49 CFR Part 572

[Docket No. NHTSA-2009-0002]

Anthropomorphic Test Devices; SID-IIs Side Impact Crash Test Dummy; 5th Percentile Adult Female

ACTION: Final rule, response to petitions for reconsideration, technical amendment.

Figure 1: Alignment of iliac wing, backer plate, and load cell/replacement¹⁶

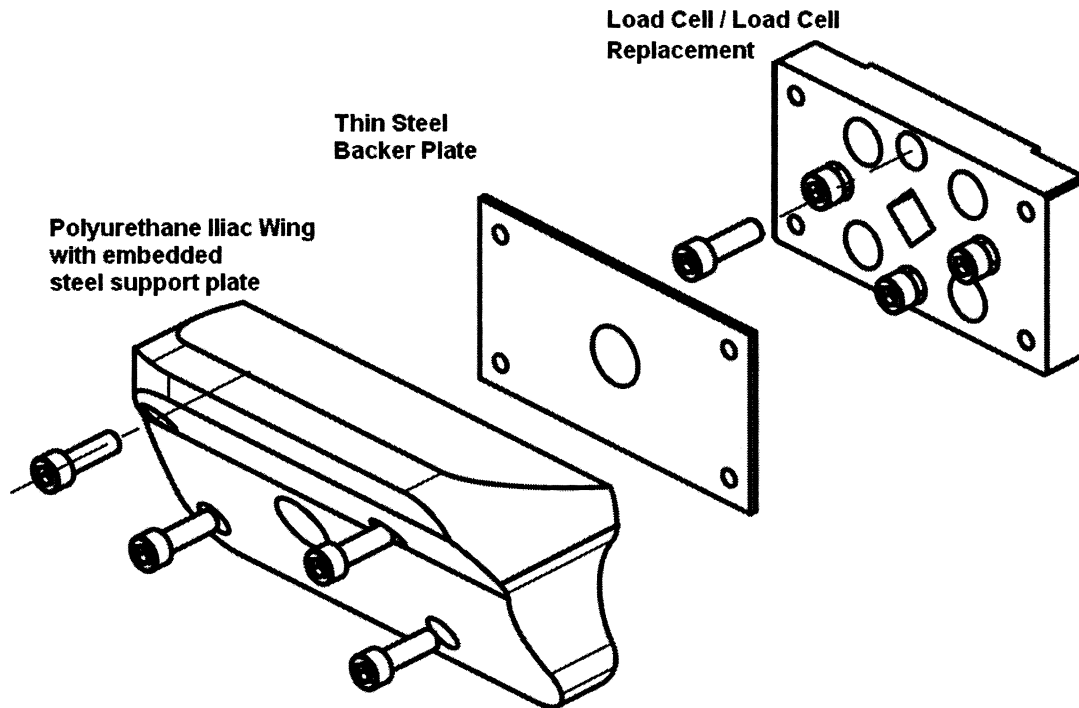
propensity to cause a load path short due to its design. According to FTSS, the original iliac wing design resulted in 1/8-inch polyurethane material being sandwiched between the embedded iliac wing support plate and the iliac load cell. It found that the amount of loading force the iliac is able to accurately measure can vary depending upon how much torque the iliac mounting screws are under, how much the polyurethane material creeps over time, and how much the iliac maintains its original shape.

FTSS stated that it has designed a new iliac substructure (support plate) that has a positive bearing surface contact between the iliac wing and the load cell to create a rigid mounting surface between the iliac wing and load cell.¹⁷ Essentially, the 1/8-inch thick polyurethane material around the mounting screw holes was replaced with 1/8-inch thick steel “standoffs” that extend from the embedded plate to the edge of the wing so that the mounting screws would draw the iliac wing to the load cell through a metal contact instead of through polyurethane. According to FTSS, this design eliminated the

potential for load path shorting since standard fastener torque values can now be specified for the iliac wing mounting hardware without losing the torque over time, and it also eliminated the material creep found in the original iliac design. FTSS recommended that NHTSA evaluate this new design and include it in the drawing package in place of the original.

artificially low measurements.” It stated, however, that while the use of the thin steel backer plate specified in the final rule (as shown in Figure 1) will reduce the likelihood of off-loading the load cell, it will not reduce deformation of the polyurethane iliac wing. It suggested that a more robust solution would be to use a rigid steel plate with standoffs that are embedded in the polyurethane iliac wing during manufacturing. The Alliance stated that “this stronger plate with standoffs eliminates the possibility of off-axis loading.”

plate between the wing and load cell, as specified by the final rule (Table 2). VRTC found that qualification test results from these two iliac configurations were very similar. The average response from wings without a backer plate was always lower than that from wings with a backer plate as seen in Table 2, but was also always less than a 2.5% reduction from the response with a plate.²⁰ Thus, the influence of the backer plate appears to be negligible. However, the plate can act to prevent load path shorting through wing contact with the center of the load cell. Although there were no instances of load path shorting during qualification tests without a plate, two quasi-static tests without a backer plate were conducted on both the softest and stiffest M3 iliac wings with standoffs. In this set of tests, the softest iliac wing made contact with the center of the load cell at a load of about 3,700 N (831.8 lb). To prevent this from happening, we have decided to retain use of the thin steel backer plate between the iliac wing and iliac load cell.

Figure 2: Examples of pelvis-acetabulum, pelvis Y acceleration response traces

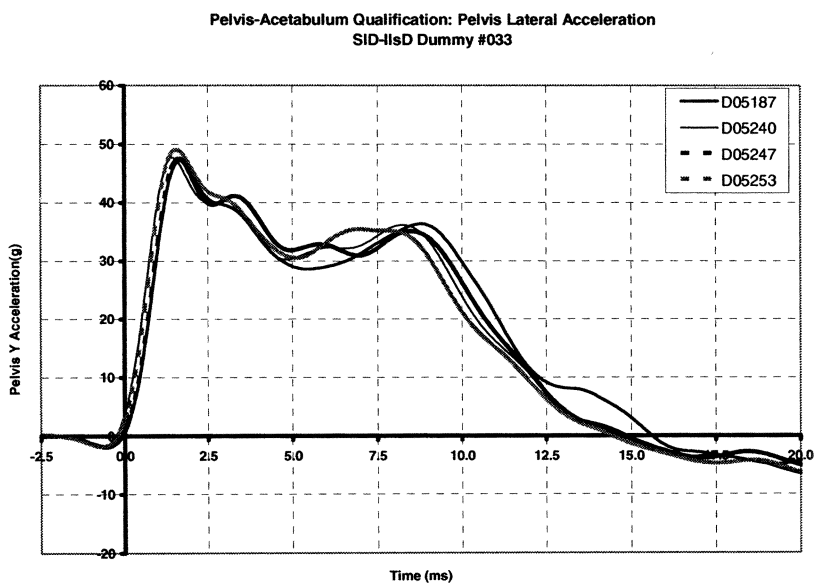
section, the first peak of the pelvis lateral acceleration response, which occurs in the first 5–6 ms, is based primarily on the plug response. Since the pelvis-acetabulum test aims to verify the pelvis response, not the plug response, the acceleration during the first 5–6 ms should not be included. However, NHTSA examined pelvis lateral acceleration traces in 11 side impact crash tests conducted with the SID-II's Build Level D dummy to determine if the first peak, which results from initial pelvis plug crush in qualification tests, was part of the dummy response in vehicle tests. (If the first peak were part of the dummy response, we would be disinclined to disregard this peak in dummy qualification.) Crash test results showed generally unimodal pelvis Y accelerations, indicating that in vehicle tests, the initial plug crush does not play a significant role in the results.

To determine after what point in time the peak lateral pelvis acceleration should be taken, NHTSA analyzed pelvis lateral acceleration traces for 46 pelvis-acetabulum qualification tests from four dummies and two labs. The data clearly showed multiple, distinct peaks as seen in Figure 2. As mentioned previously, the first main peak and second small "bump" in the data are due to the pendulum impacting the pelvis plug and (most likely) the pelvis flesh, respectively. The second major peak (called the "second peak" henceforth) represents the response of the dummy after the leg mass comes into play, and is the measure of interest for qualification of the dummy. As the petitioners claimed, the first peak was consistently higher than the second peak. In order to prevent measuring this first, less meaningful peak for qualification, the petitioners recommended that the peak pelvis acceleration value be taken after 5 ms after probe contact with the dummy.

two tests, the peak of the main dummy response occurred just before 6 ms (see Figure 4), causing the peak after 6 ms to be slightly less than the actual peak. This occurrence was rare, though, and only resulted in an error of approximately 0.1 g for both tests. As a result of this evaluation, this final rule specifies that the peak pelvis lateral acceleration be taken after 6 ms.

Figure 3: Pelvis Y acceleration traces (with the exception of D05149) with main response peak values lower than the acceleration at 5 ms

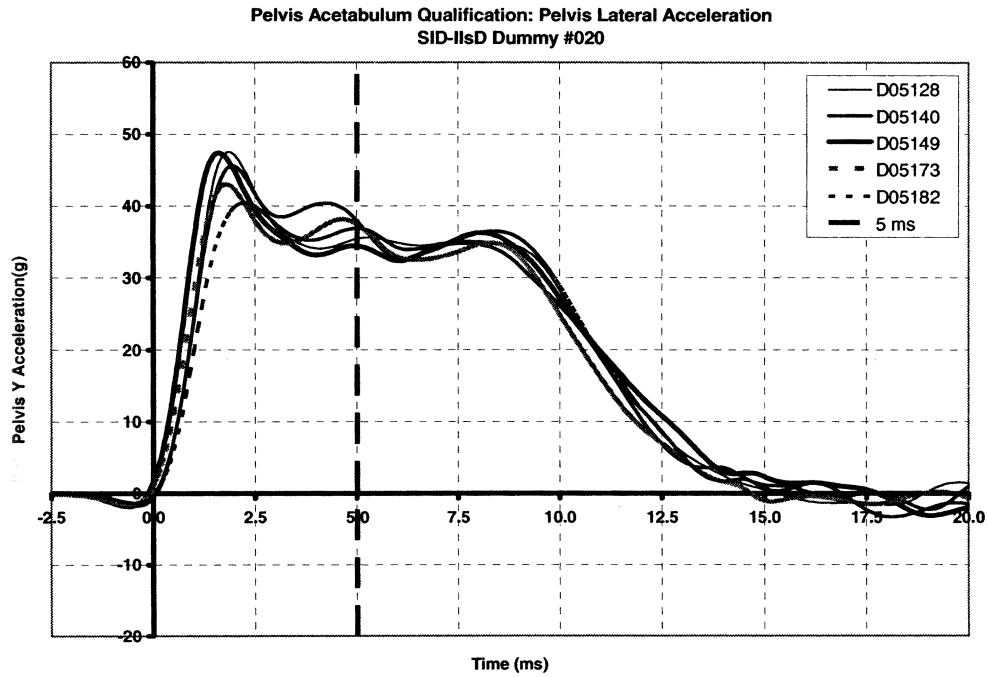
It was not clear from the data that 5 ms was the most appropriate time to begin measuring a peak value. For each of these 46 traces, the peak values after 5 ms, 6 ms and 7 ms were obtained in order to determine how much time after probe impact should be disregarded to prevent the first peak from being measured. It was found that in five of the 46 tests, the maximum value after 5 ms was higher than that after 6 or 7 ms, because the value of the decreasing “first peak” response at 5 ms was higher than the main dummy response peak value. Four of these 5 instances occurred in Dummy S/N 20, and are seen in Figure 3 below. These cases led the agency to determine that the peak should be taken after 6 ms. However, in

Figure 5: Peak shoulder deflections generated at probe impact velocities of 4.2 – 4.5 m/s

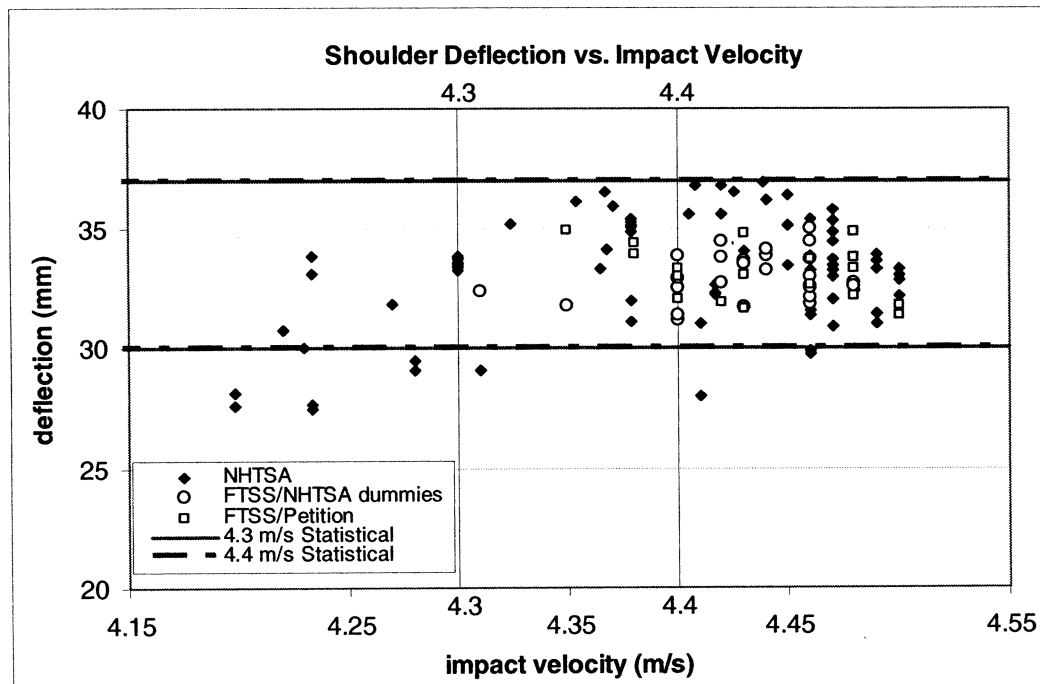
Figure 5 shows the peak shoulder deflection responses with respect to the impact speed of the pendulum. It is observed that the peak deflections are noticeably lower at impact speeds of approximately 4.2 m/s. Because of this observation, the qualification performance corridors have been formed with the mindset that the statistical corridor (which is centered at the mean

of the data set) may have to be adjusted to accommodate low deflections at the low impact velocities, since the mean of the 4.2–4.4 m/s data set may be slightly high due to the majority of tests being conducted between 4.3–4.4 m/s. The revised corridors are discussed in “Analysis and Development of SID–IIIsD Qualification Specifications in Response to Petitions for Reconsideration (July 1,

2008),”³¹ and in section XI.a of this preamble. We believe that by adjusting the performance corridor to reflect deflection responses at lower impact velocities, the new performance corridor will satisfactorily represent dummy responses over the full range of the revised specified impact velocities.

**FIGURE V9-A
ILIAC IMPACT**

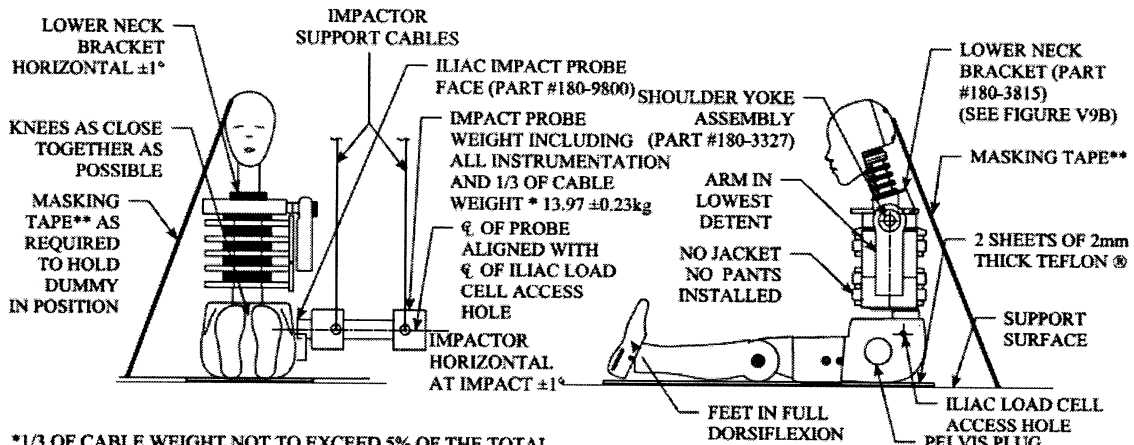
(5) The midsagittal plane of the dummy is vertical, and superior surface of the lower half neck assembly load cell replacement (180-3815) in the lateral direction is within ±1 degree relative to the horizontal as shown in Figure V9-A.

■ 13. Figures V4-A, V9-A and V9-B in "Appendix A to Subpart V of Part 572-Figures" are revised to read as follows:

**FIGURE V9-B
ILIAC IMPACT
(NON-IMPACT SIDE VIEW)**

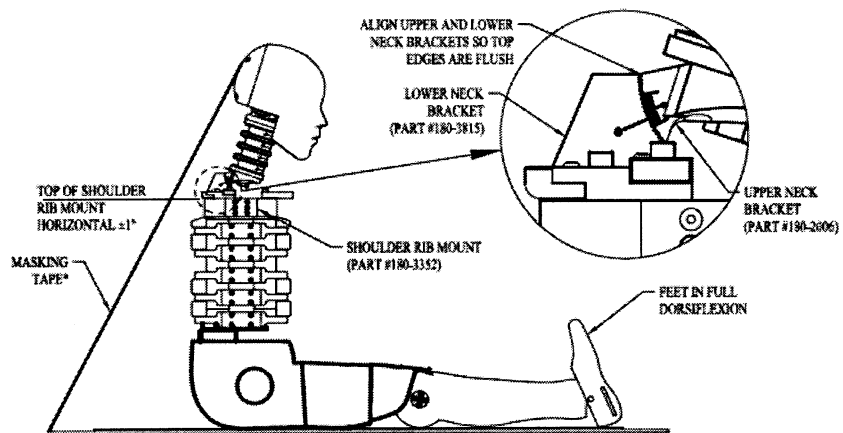
(6) While maintaining the dummy's position as specified in paragraphs (b)(3), (4) and (5) of this section, the top of the shoulder rib mount (180-3352) orientation in the fore-and-aft direction is within ±1.0 degree relative to horizontal as shown in Figure V9-B in Appendix A to this subpart.
